E5062A-06

S E R V I C E N O T E

E5062A ENA Series Network Analyzer, 300 kHz to 3 GHz

When replacing A51 LCD, fasten the TORX T15 screws using a torque screwdriver (set to 1.02 N-m / 9.0 lb-in).

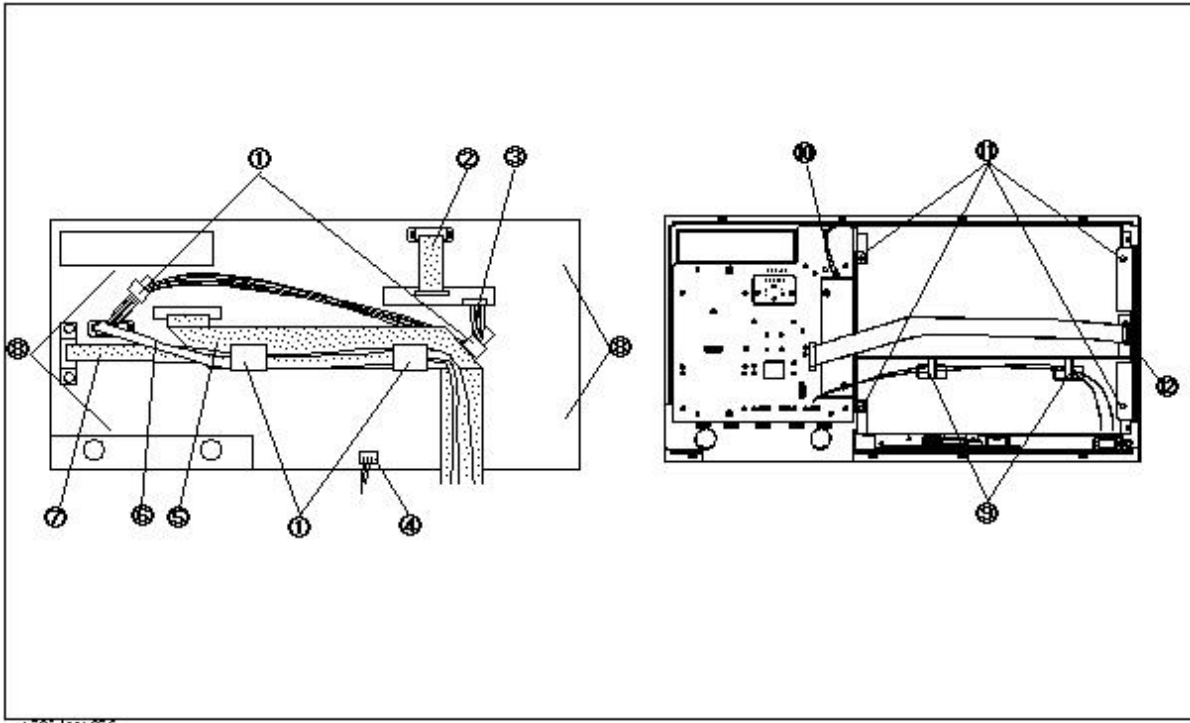
When replacing the A51 LCD, no torque info is shown in the service guide.

If you fasten the screw with over the appropriate torque, A51 LCD might be damaged, and if you fasten the screw with under the appropriate torque, LCD module might not be fixed against the vibration.

Fasten the TORX T15 screws (item 11) using a torque screwdriver (set to 1.02 N-m / 9.0 lb-in).
